1R Information Letter No. 18-1
Sequence No. 9
April 30, 2018

TO: Caterpillar Mailing List
SUBJECT: Changes to 1R Humidity Probe Location

(Revises Test Method D6923-17)

FIG. A4.1 Intake Air Sensor Installation

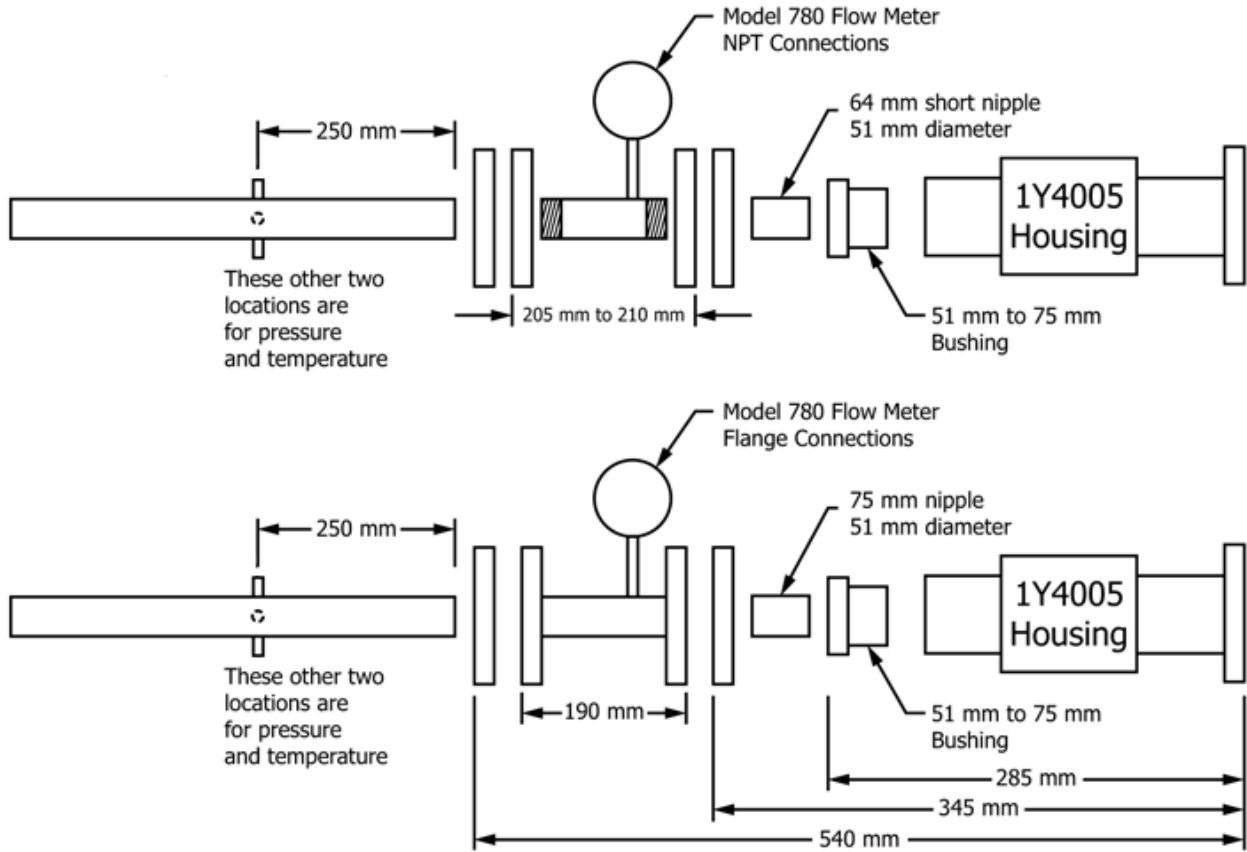
During the March 7th CAT Surveillance Panel meeting it was decided to update the location of the humidity probe installation. The humidity probe location has been changed to match the probe location of the 1P test. Figure A4.1 has been revised and new Figures A4.2 and A4.3 have been added to D6923. All three figures are attached. This change is effective March 7, 2018.

FIG. A4.2 Humidity Probe Installation Location

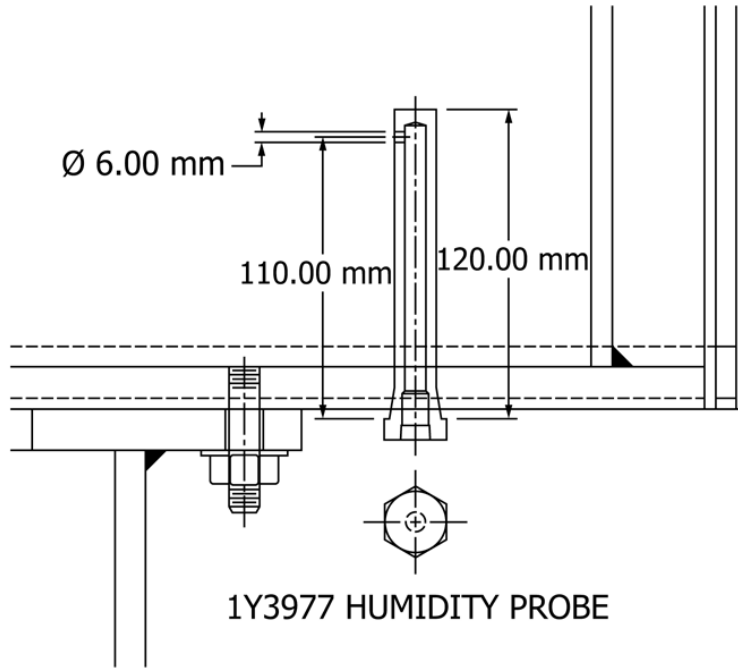
Figs. A4.2 and A4.3 illustrate the humidity probe installation locations.
